National Transportation Safety Board

Safety Recommendation

Date: February 10, 2011

In reply refer to: A-11-7 through -11

Figure. Location of FOD.

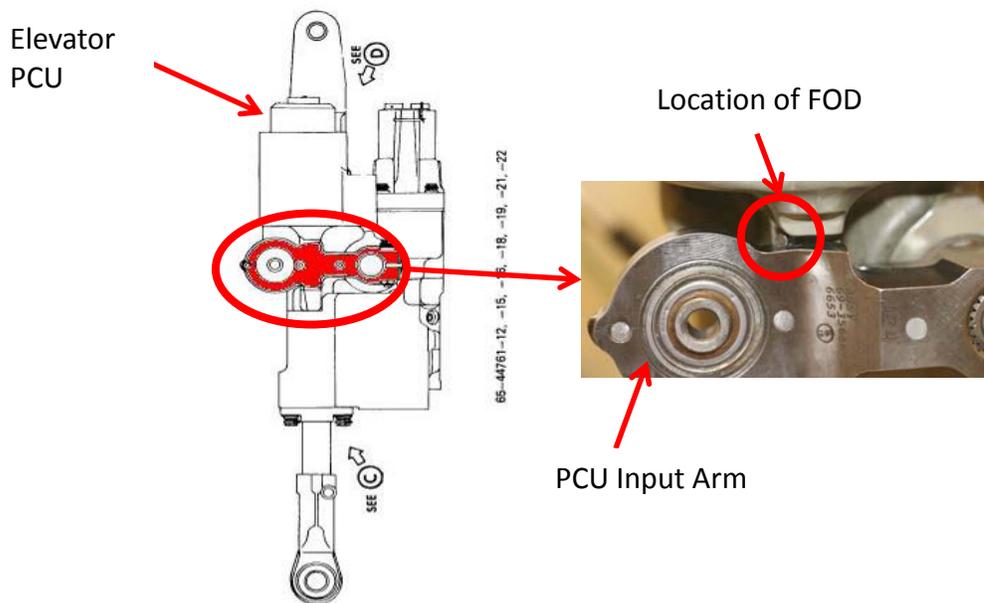
Tailwind Airlines' postincident inspection of the elevator PCUs revealed that the system "A" elevator PCU input arm assembly was jammed by a piece of FOD (a metal bearing roller) in a position that offset the control arm in a downward direction. With the control arm deflected downward and with hydraulic pressure available, the PCU would be commanded to move the elevator to a position that would pitch the aircraft nose up. The incident airplane's flight data recorder (FDR) recorded an aircraft pitch up during the landing flare just before the commanded go-around maneuver. Because of the way the elevators are linked together, a jam in one PCU will cause both elevator surfaces to deflect in the same direction. (The two sides of the system cannot be disconnected so that the unjammed PCU can control the elevators.)

The NTSB notes that the protective covering used for the aileron input arm assemblies would likely also help protect the elevator PCUs on 737-300 through -500 series airplanes from FOD. The NTSB concludes that FOD within any flight control system is a serious concern because debris may migrate and become lodged within the controls, resulting in a jam of the control system during a critical phase of flight. Further, the NTSB concludes that special protection (in the form of protective covering or other methods) for the elevator PCUs would ensure that FOD does not jam the elevator PCU input arm assembly. Therefore, the NTSB recommends that the Federal Aviation Administration (FAA) require Boeing to develop a method to protect the elevator PCU input arm assembly on 737-300 through -500 series airplanes from FOD. The NTSB further recommends that the FAA, once Boeing has developed a method to protect the elevator PCU input arm assembly on 737-300 through -500 series airplanes from

Require Boeing to develop a method to protect the elevator power control unit input arm assembly on 737-300 through -500 series airplanes from foreign object debris. (A-11-7)

Once Boeing has developed a method to protect the elevator power control unit input arm assembly on 737-300 through -500 series airplanes from foreign object debris as requested in Safety Recommendation A-11-7, require operators to modify their airplanes with this method of protection. (A-11-8)
